**DEL WEBB AT MIREHAVEN PHASE 3 & 4  
 (TRACT M AND TRACT N-2-A-1, WATERSHED)**

Re: Del Webb at Mirehaven Phase 3&4 Grading and Drainage Plan and Drainage Report  
Engineers Stamp Dated: 05/10/2018 (H09D017G)

Enclosed are responses to the comments provided on June 19, 2018. Responses are listed in red below.

**PRELIMINARY PLAT**  
**DEL WEBB @ MIREHAVEN PHASE 3 AND PHASE 4**  
 (REPLAT OF TRACT N-2-B-1, N-2-B-2 AND TRACT N-2-C-1)  
 ALBUQUERQUE, NEW MEXICO

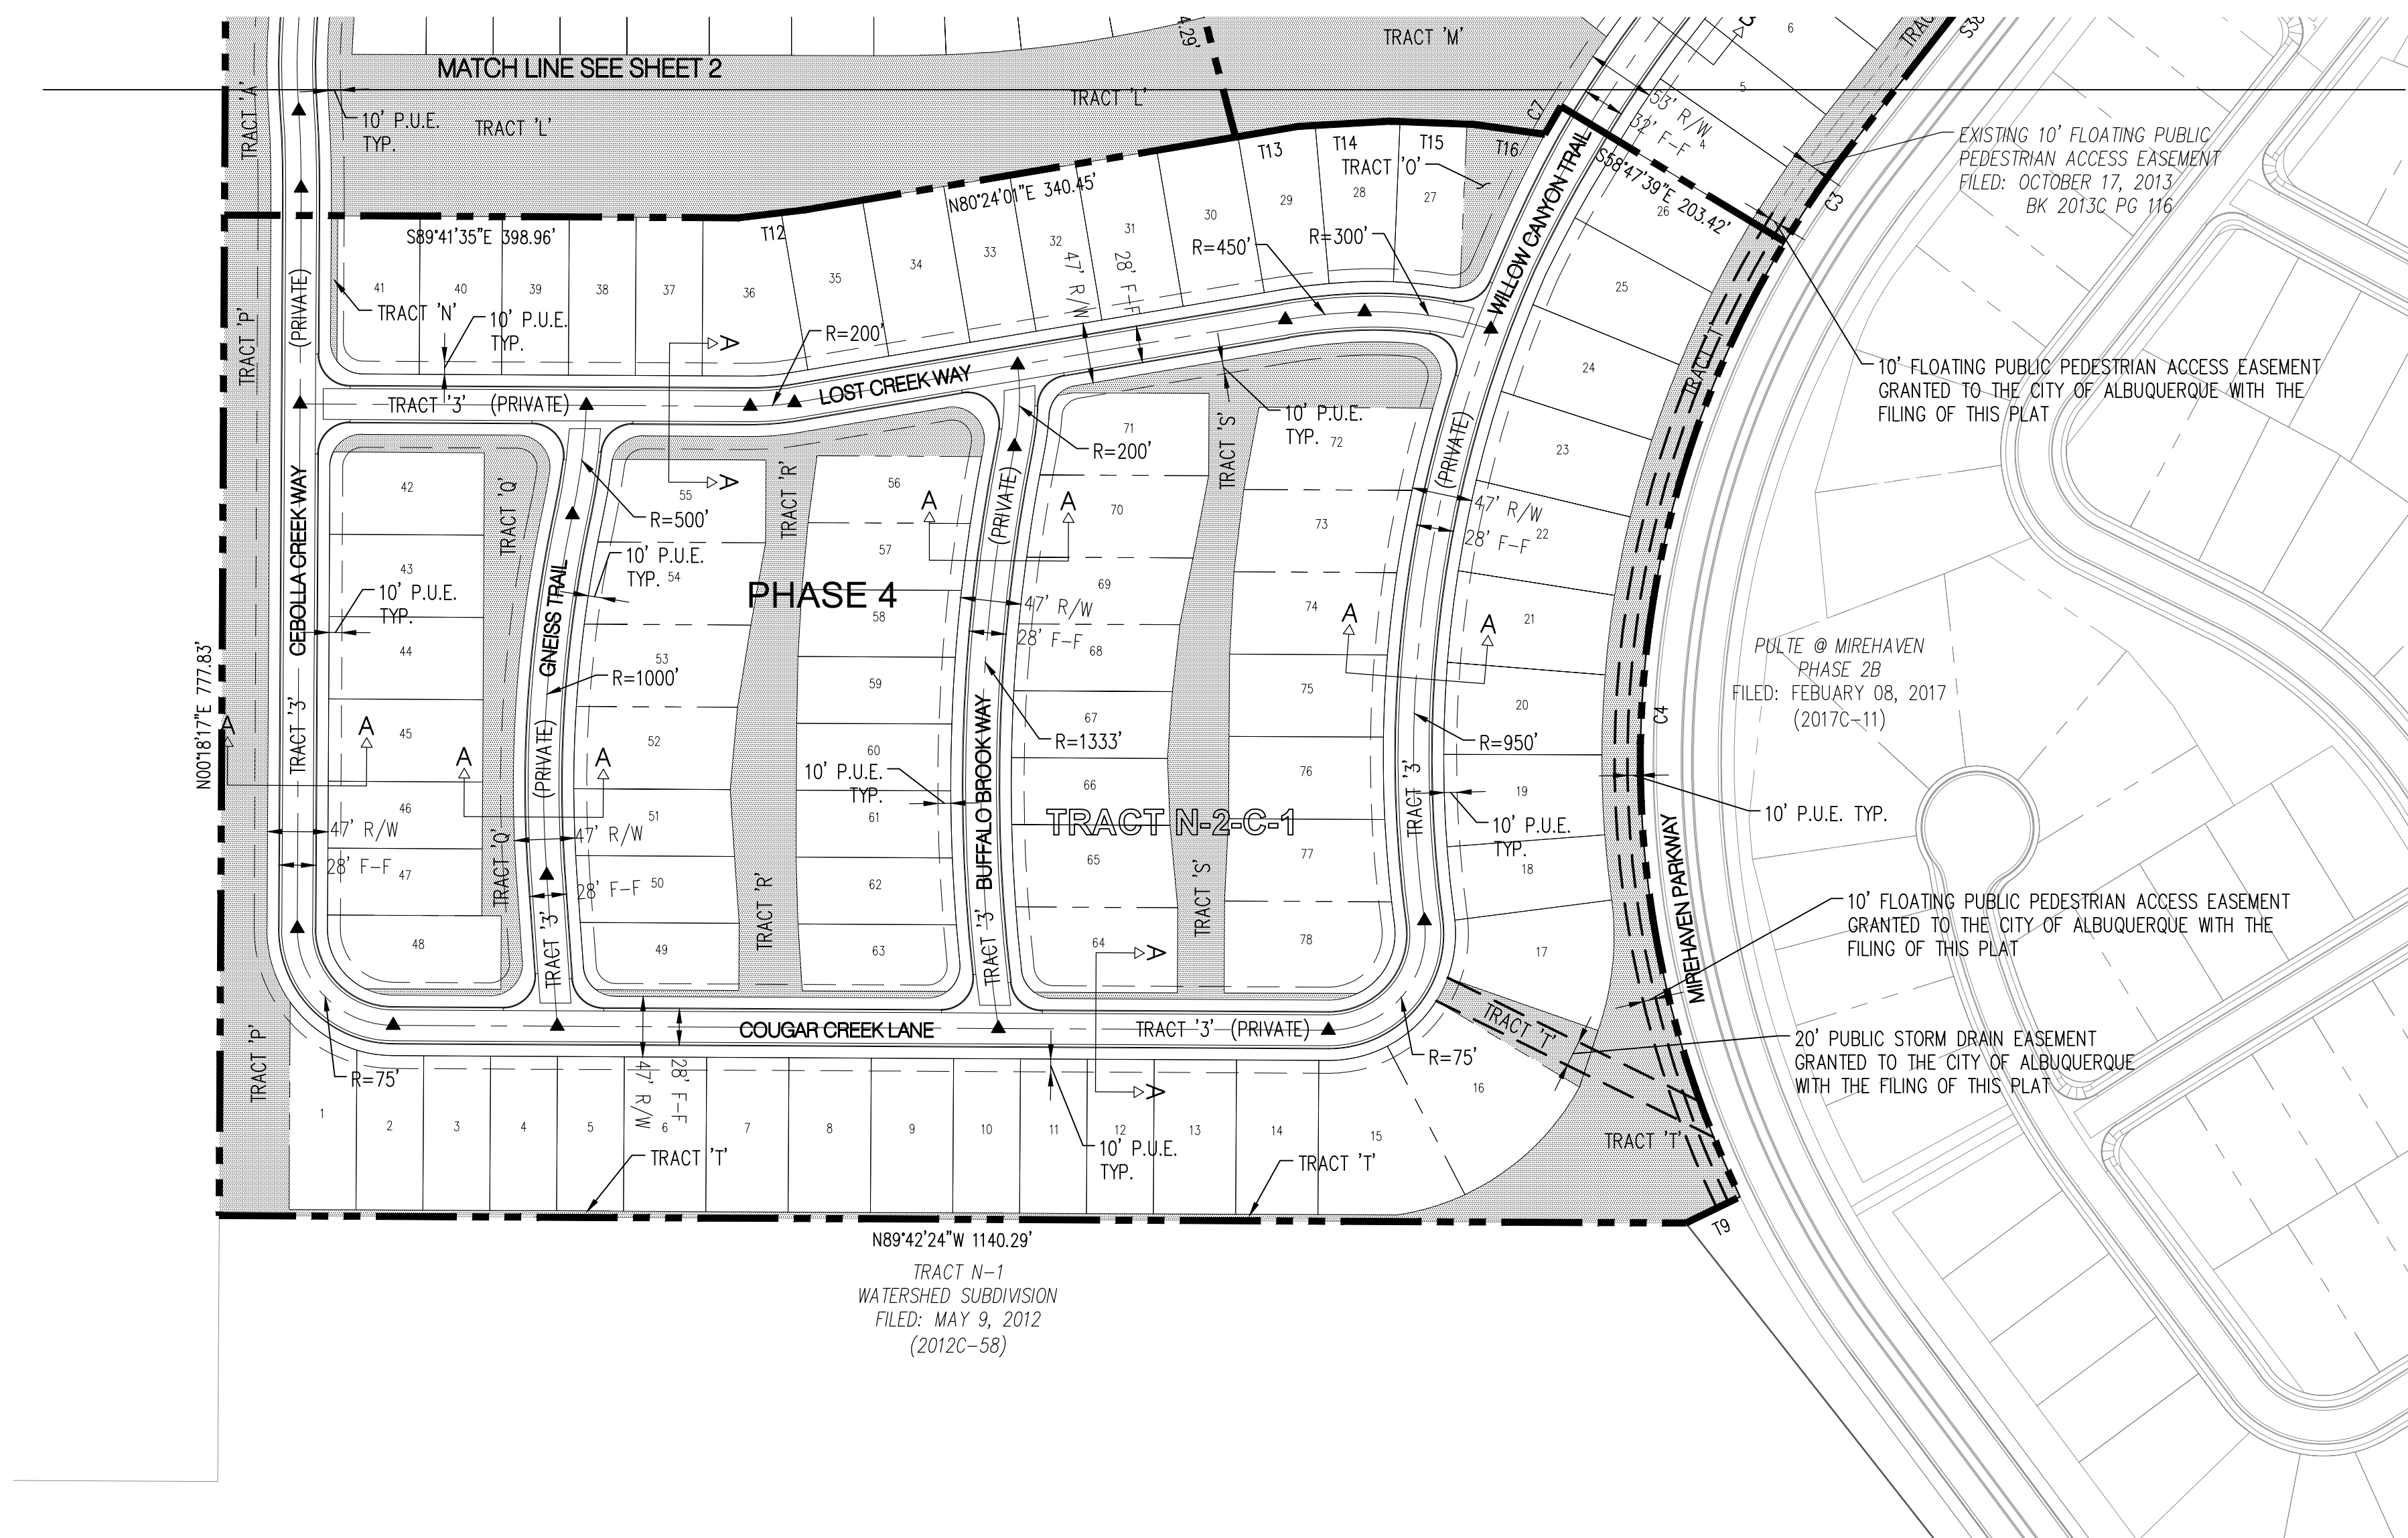
6. Public Drainage easements must be noted on the preliminary plat on Tracts 1, 2, 3, A,M, P and T. Private drainage easements must be noted on the remaining tracts. No differentiation between public and private is evident on the plat. This has been updated on plat. However, Tract T is incorrect it should be Tract L. Tract T is located along Tierra Pintada where Tract L is west of Tract M. Note 10 was previously added to address the private easements on all other tracts. We have also added a table to indicated which tracts have which easements. The planview tends to get to busy when there is too much hatching or shading.

SHEET 3 of 3

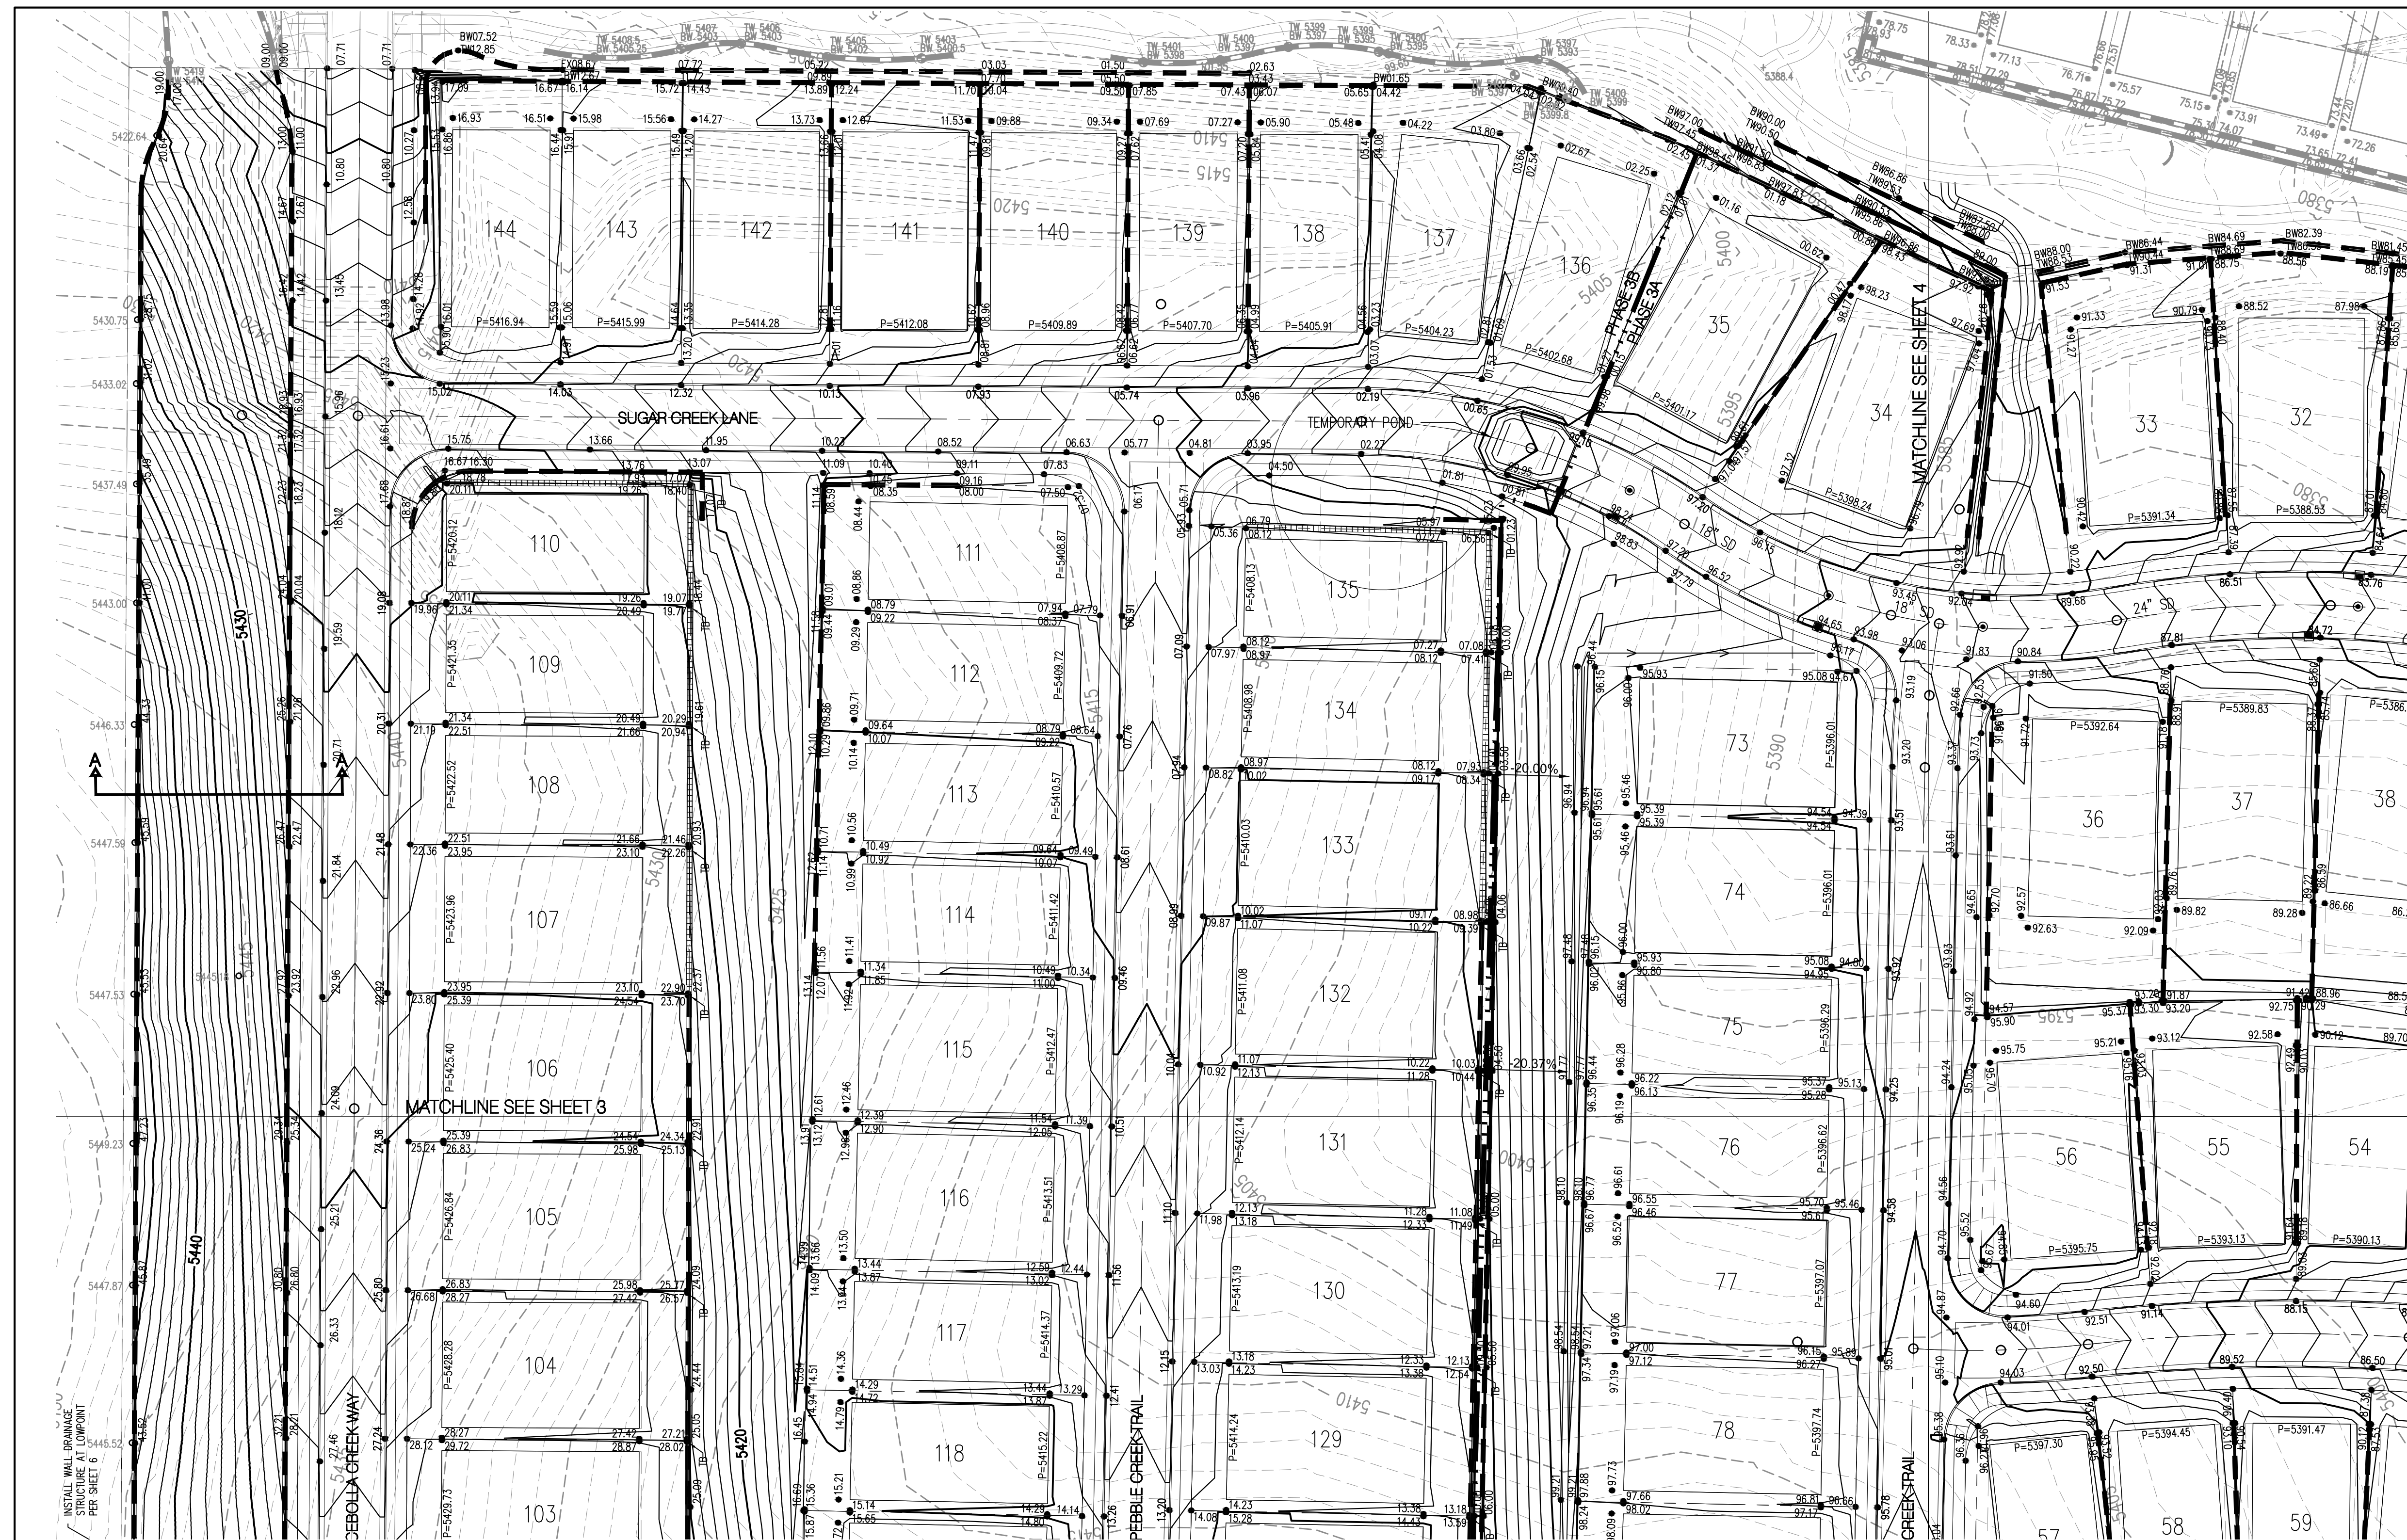
7. Private maintenance of all drainage improvements in all drainage easements, both surface and subsurface, must be provided by adding the standard drainage easement note on the preliminary plat and changing the wording of the note on the right hand side of sheet 2 of the preliminary Plat. Plat has been updated to remove the maintenance and refer to Sheet 3 Maintenance Note. Surface and subsurface and been removed and only reads Public Drainage Easement.
